**0014** Technical Service Information**Subject:** Cylinder head gaskets**Relates to:** 61-37250-00 / -10**Make:** Opel**Model(s):** Agila, Corsa**Engine code:** Z 10 XEP**Repair thickness CHG 1.0 Opel  
Twinport / Z 10 XEP**

Figure\_Cylinder head gasket, Reinz no. 61-37250

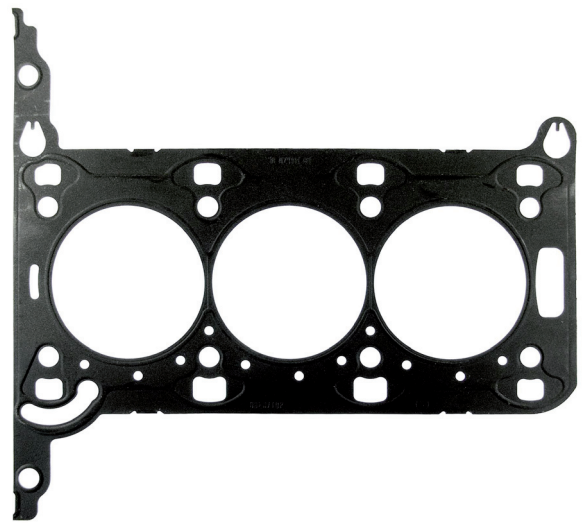
With the new exclusive repair thickness for the Cylinder Head Gasket 61-37250-00 = Opel 56 07 838, Dana offers the perfect solution for reliable sealing of reworked cylinder heads and cylinder blocks.

The repair thickness is 0.25 mm thicker than the original. After necessary surface machining, this thickness thus offers best sealing results up to this measurement.

The order number for the repair thickness is **61-37250-10**.

Caution: After the cylinder head and cylinder block have been machined, the surface roughnesses must be in a tolerance band between 7 µm and 20 µm. The waviness value should not exceed 20 µm.
